PLANNING, ZONING, & BUILDING DEPARTMENT  
PZ&B Staff Combination Memorandum: Architectural Commission and Town Council

SUBJECT: ARC-24-035 (ZON-24-043) 620 N LAKE WAY (COMBO)

MEETING: MAY 29, 2024 ARCOM  
JUNE 12, 2024 TC

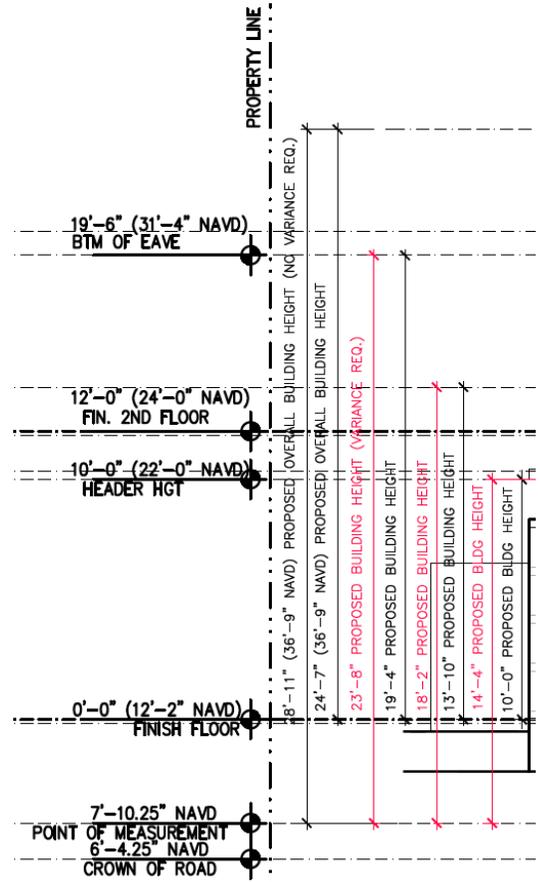
Variations are required to achieve the application as proposed. The slope of the lot increases rapidly from east to west, and the zoning code requires that Zero Datum for the point of measurement be taken 18 inches above the highest crown-of-road. This puts the point of measurement at 7.85' North American Vertical Datum (NAVD), which is actually *below* existing grade at the front of the structure (approx. 9.67' NAVD). The applicant is proposing their finished floor higher than existing grade at 12.17' NAVD, about 4.32' higher than the point of measurement. The difference in the finished floor and the required point of measurement must be figured into the building height calculation (even though it is below grade) and the portions of the structure below the finished floor, but above the point of measurement, must be calculated into Cubic Content Ratio.

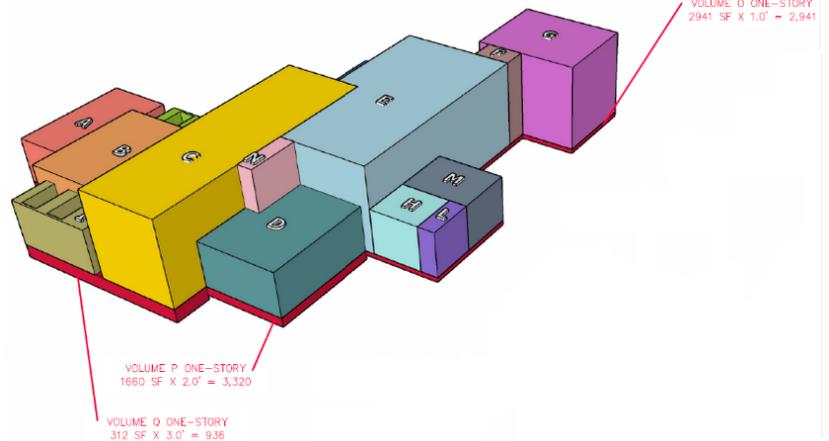
Variance 1 pertains to the proposed building height of the structure. The structure is proposed to be constructed with a building height of 23 ft., 8 in. where a maximum building height of 22 ft. is the maximum building height permitted. Staff will note that this is the height, as taken from the point of measurement, which is *below existing grade*. The applicant is proposing a finished floor elevation of 12.17' NAVD, and if the building height measurement was taken from this point, the building height would be 19'-4" below the 22' maximum permitted. The definition of building height clearly establishes the point of measurement at 18" above the crown of road, which does not take into account this type of parcel which experiences a somewhat significant change in grade as it traverses from the street on the east side of the parcel to the rear of the lot on the west side of the parcel. The difference in grade from the highest and lowest points on the lot are approximately 7.5'.

Code Section	Permitted	Proposed	Variance
<a href="#">Variance 1: Sec. 134-893(b)(10)b.</a>	Maximum building height of 22'-0" from point of measurement.	Maximum building height of 23'-8" from point of measurement.	+1.67'
